RE: Town of Peshtigo Update

SUBJECT: Response to Deep Aquifer Bedrock Well Design and Long-Term Monitoring –
Interim Response Status Update
JCI/Tyco FTC PFAS, 2700 Industrial Parkway South, Marinette, WI
BRRTS #02-38-580694

SUBJECT: Response to *Additional Site Investigation Work Plan*
JCI/Tyco FTC PFAS, 2700 Industrial Parkway South, Marinette, WI
BRRTS #02-38-580694

7. ENVIRONMENTAL PROTECTION REPORT FIGURES/Deep Monitoring Well.aprx 8/19/2023 11:45 AM

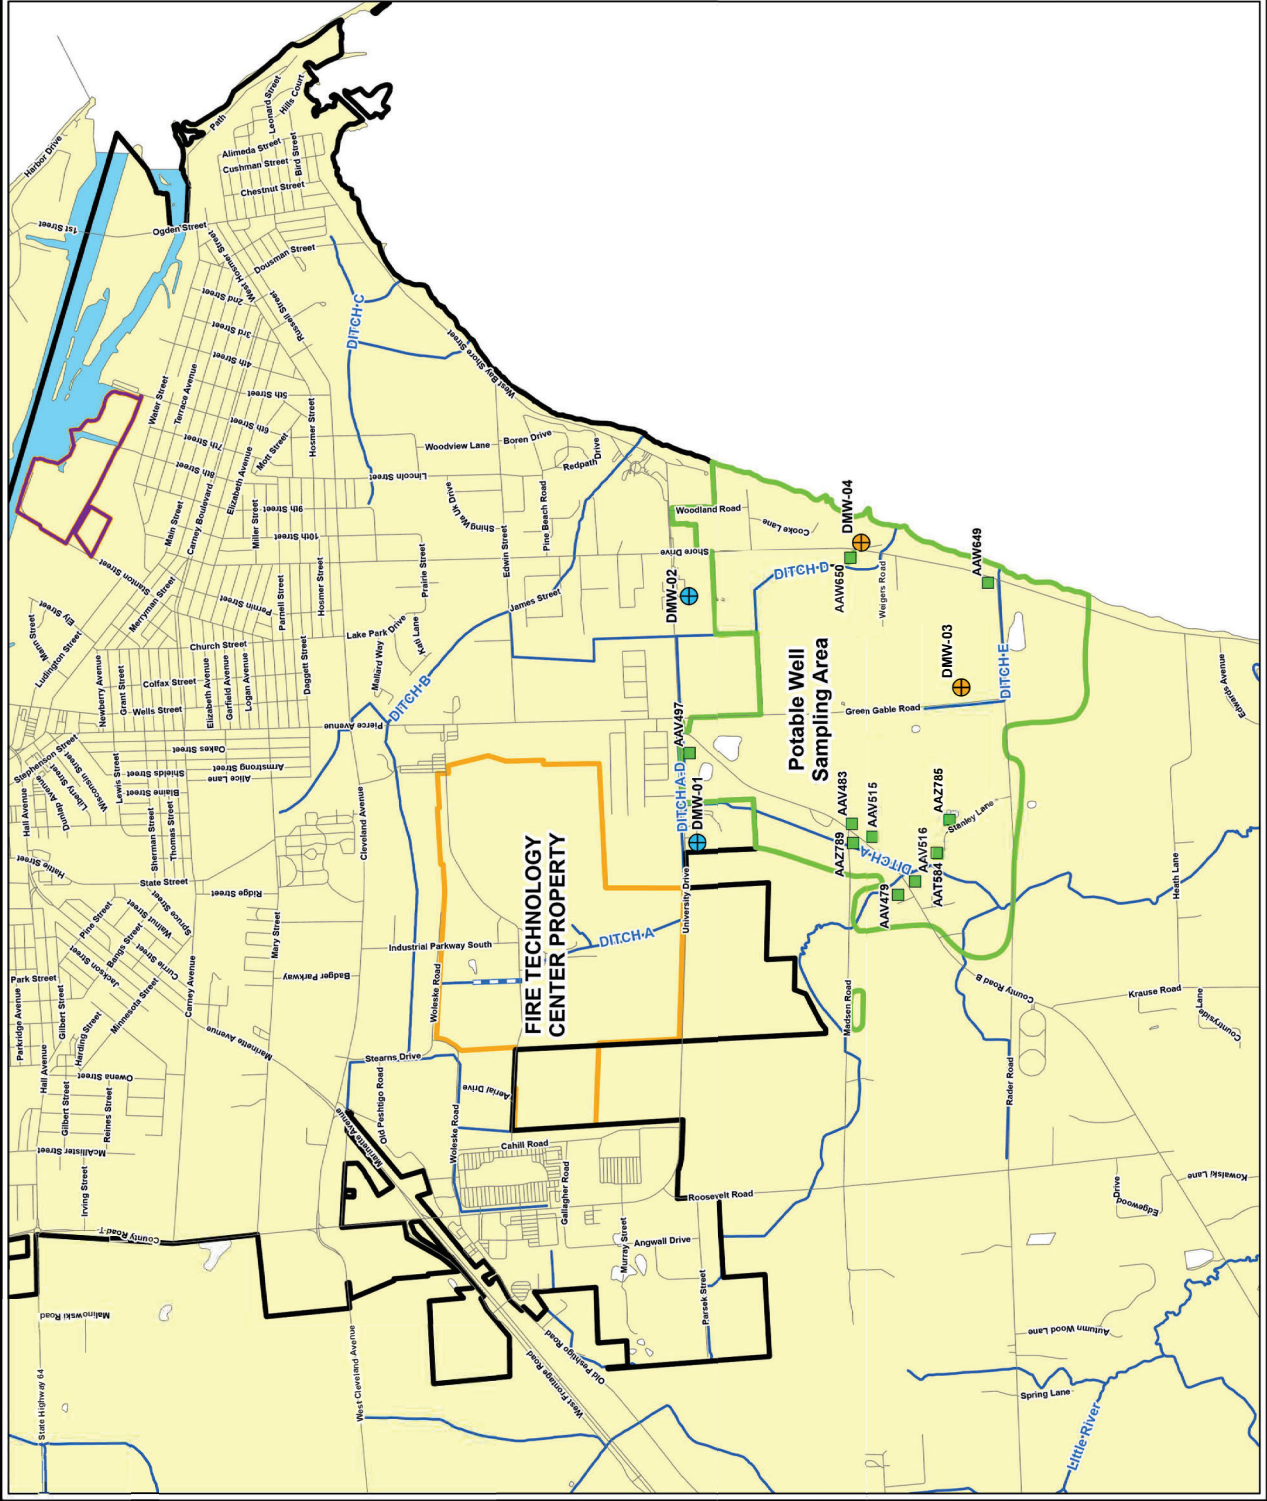
- Two of the deep monitoring wells (DMW-01 and DMW-02) were installed last spring, and installation of the other two (DMW-03 and DMW-04) began this month.

- The locations are shown on the attached map taken from JCI/Tyco's [Aug. 2023 Deep Well Status Update](#).
 - DNR recently sent a [Response to the Deep Well Update](#) to JCI/Tyco

- As-built design schematic for deep monitoring well DMW-01 (with liner), and an evaluation about the effectiveness of the design modification in preventing sulfur rich water from entering the well.

- Well construction reports, geophysical logs and laboratory reports.
- Table with well construction details and map showing the as-built locations of the four wells.

- Update Figure 1 and Table x.4 and submit the updates **quarterly** to the DNR starting in Feb. 2024 until installation of the deep private wells are complete. Please add the well depth to the table and note if a well required a retrofit with deeper liner.
